Requests to be Heard

13 September 2022

Planning and Amenity
Delegated Committee Meeting

Bayside
CITY COUNCIL

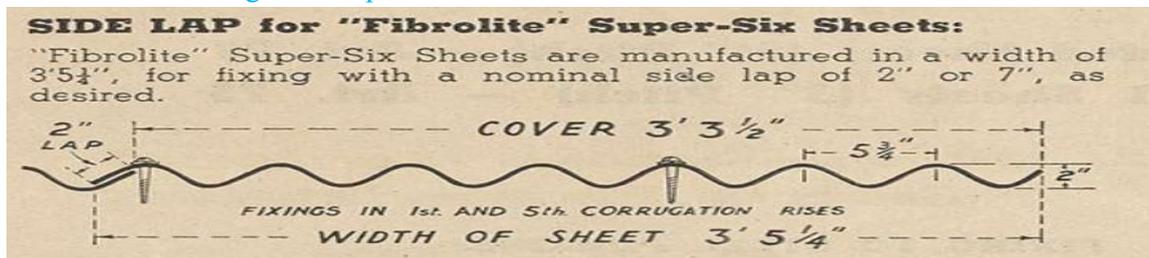
- The weight of the buildup when it is wet is considerable and has caused deformation of the main beam in the living room that bridges to the chimney.

Water ingress into inside of home, walls and ceiling and damage to internal roof structure.

No verifiable evidence supplied with application. •

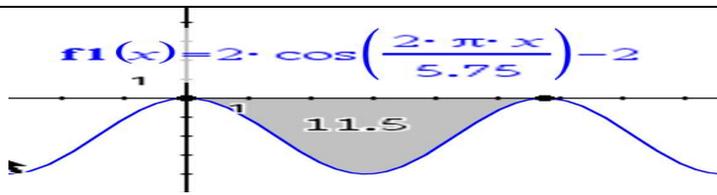
Cord at high tension pinned along length of main beam in living room shows beam has permanently sagged 4 cm at lowest point under the added weight of the pine needles/mud.

Super six corrugations, each corrugation when filled has a cross sectional area of 11.5 sq in(74 cm²).

Dimensions of total roof supported = 7.4 m x 4.7 m

Volume capacity of corrugations = $7.4 \times 0.0074 \times (4.7 / (5.75 \times 0.0254)) = 1.77 \text{ m}^3$

When full with pine needle/mud mix (density ~ 1.8 kg/L) this corresponds to an extra 3200 kg load on the roof, half of this 1600 kg being added to the main beam.

Upstairs Property floorplan and direction of the lights.

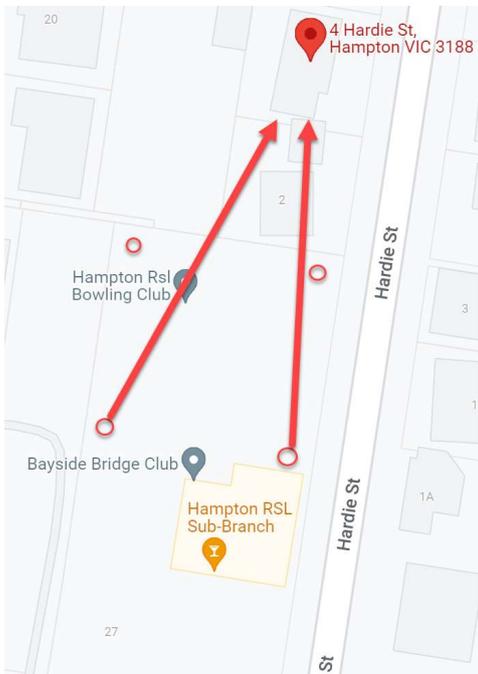
As you can see, we have use the most affected room to get to the kitchen, dining, lounge.
